DEVELOPMENT FACILITATIVE TEAM (DFT)
HEARING OCTOBER 2, 2024
UPDATE: 06/05/2024 Application Submittal

Project Number PR-2024-010446
SI-2024-00774-SITE PLAN DFT

RE: Site Plan Amendment for new construction

APPLICANT RESPONSES TO THE STAFF COMMENTS:

3 SW1 DUMPSTER ENCLOSURE PLAN AND DETAILS

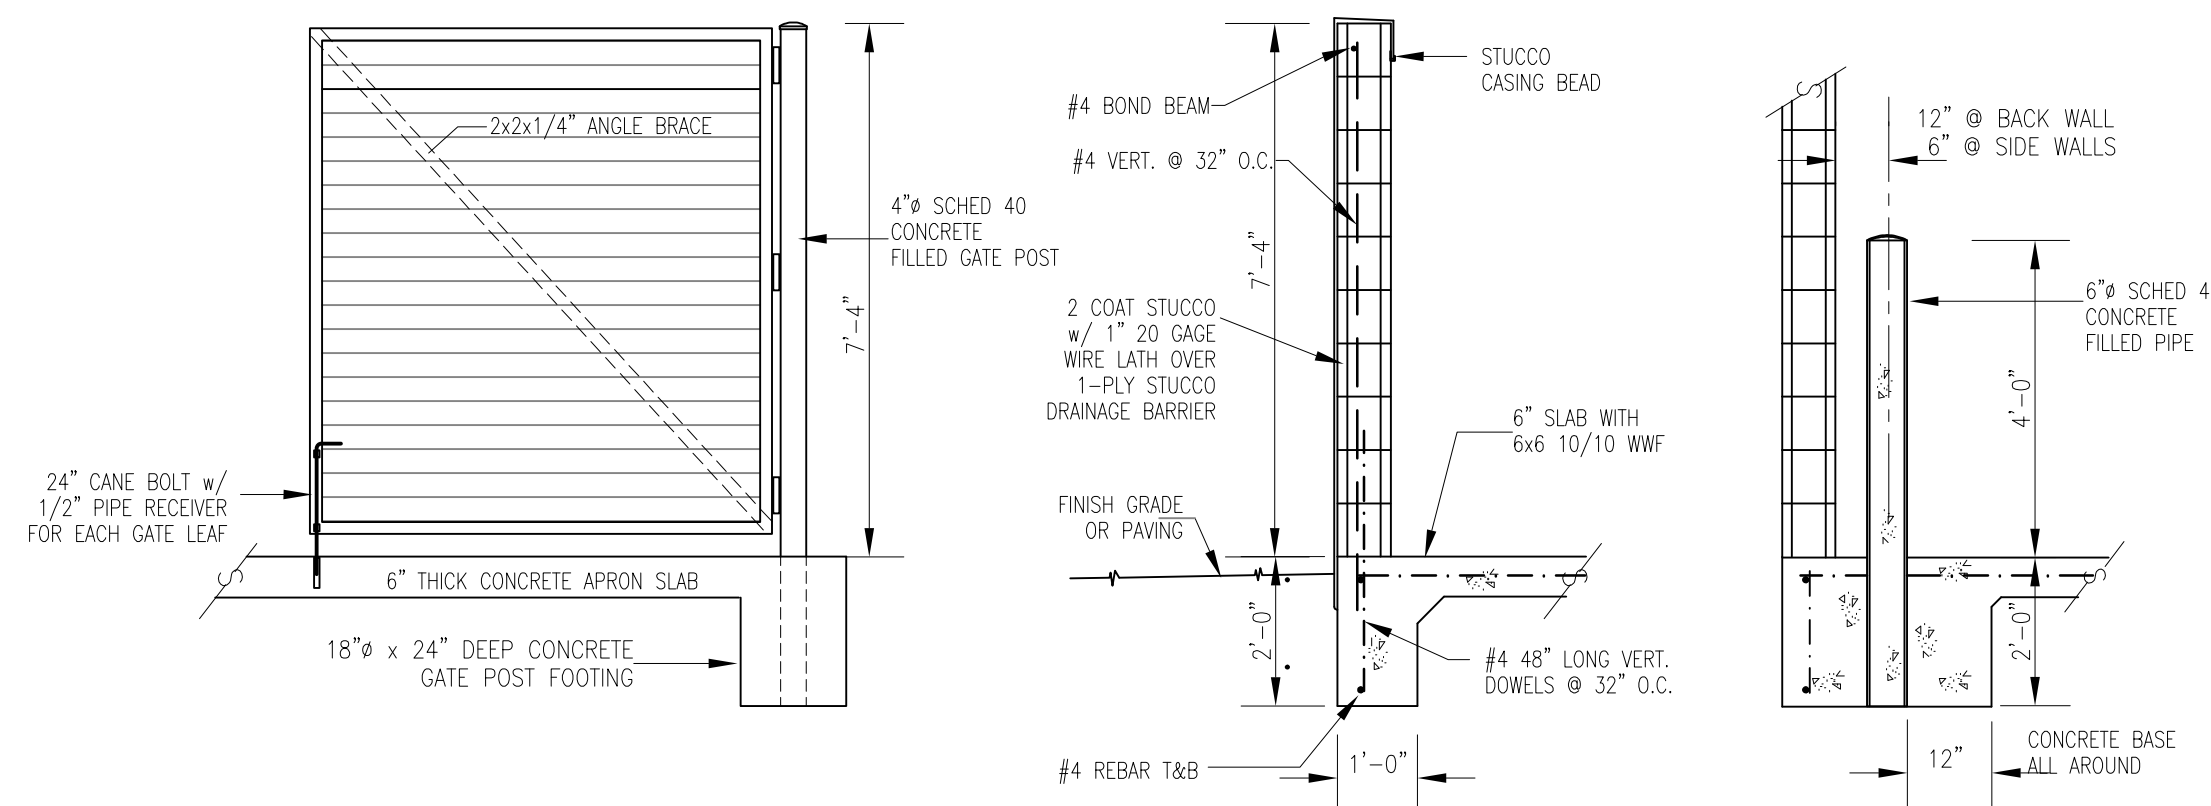
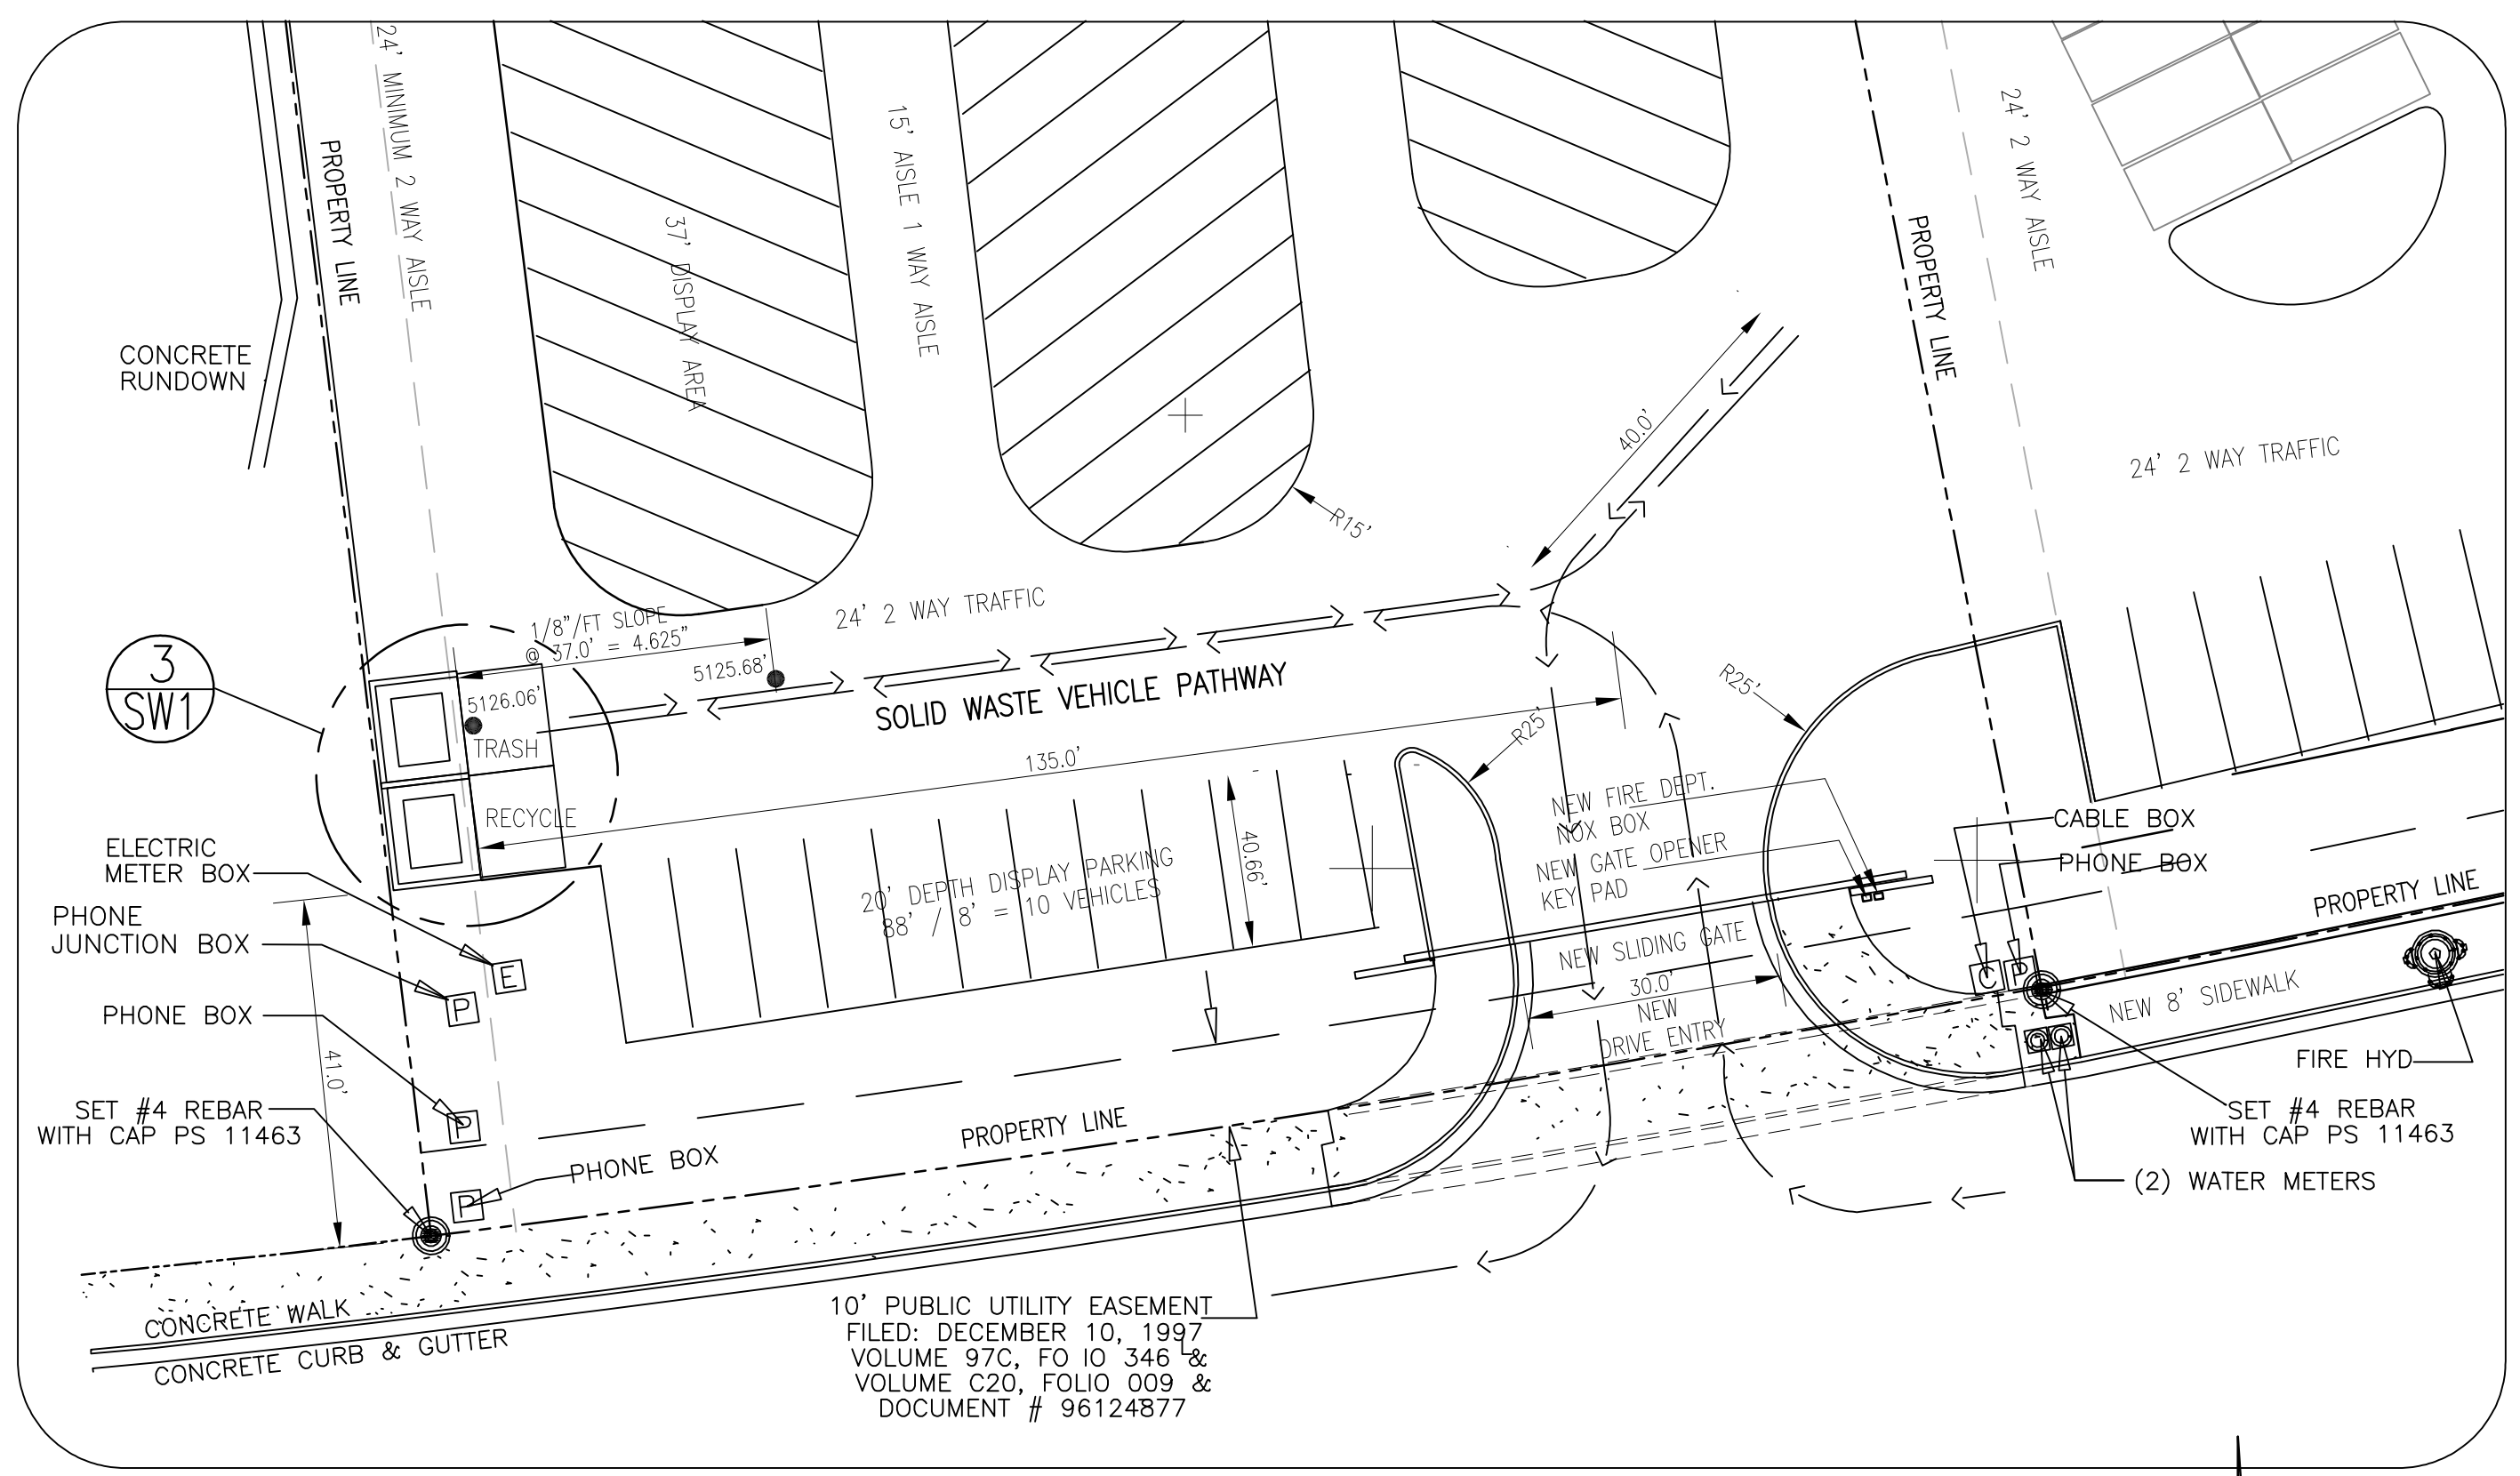
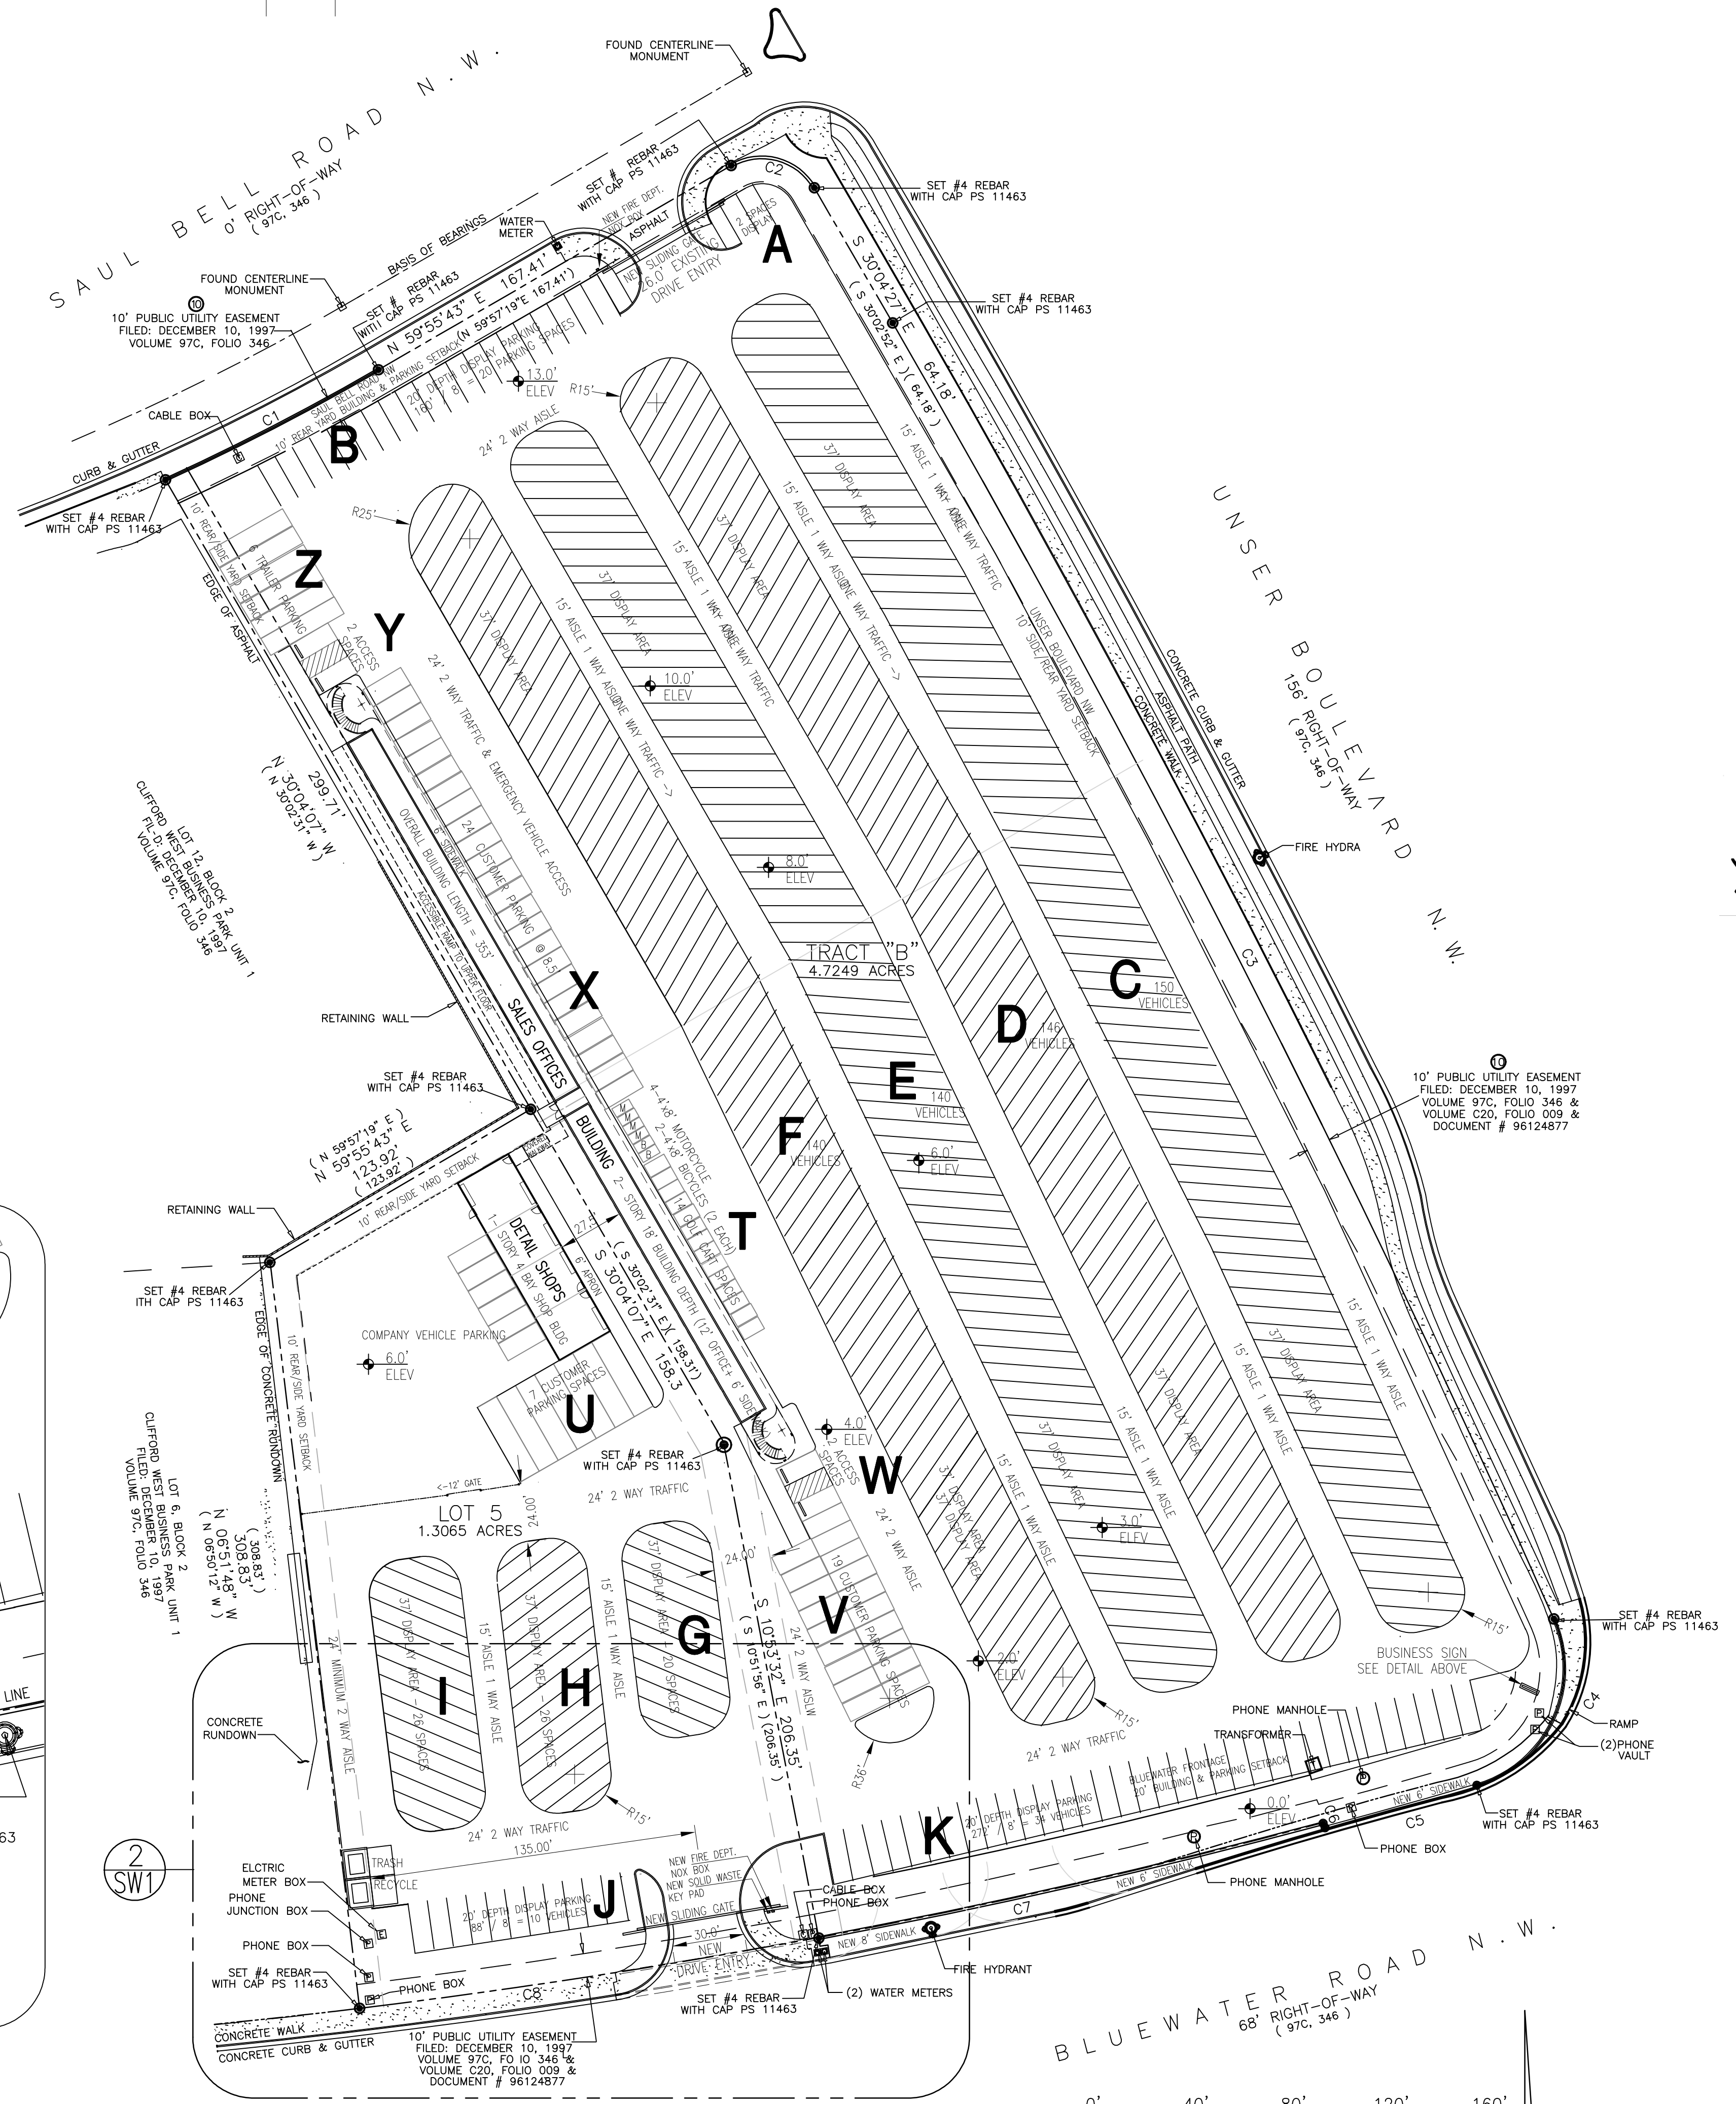
Outdoor loading, service, and refuse areas shall be integrated into the building design if possible, or shall be located where they are not visible from streets, City parks, Major Public Open Space, trails, or major arroyos adjacent to the lot or from adjacent properties with low-density residential development to the maximum extent practicable.

SOLID WASTE REFUSE CONTAINERS ARE SCREENED FROM PUBLIC VIEW BY STUCCO FINISHED WALLS 7'-4" IN HEIGHT

SOLID WASTE REFUSE CONTAINERS ARE SCREENED FROM PUBLIC VIEW BY STUCCO FINISHED WALLS 7'-4" IN HEIGHT AND LESS THAN 20' IN LENGTH
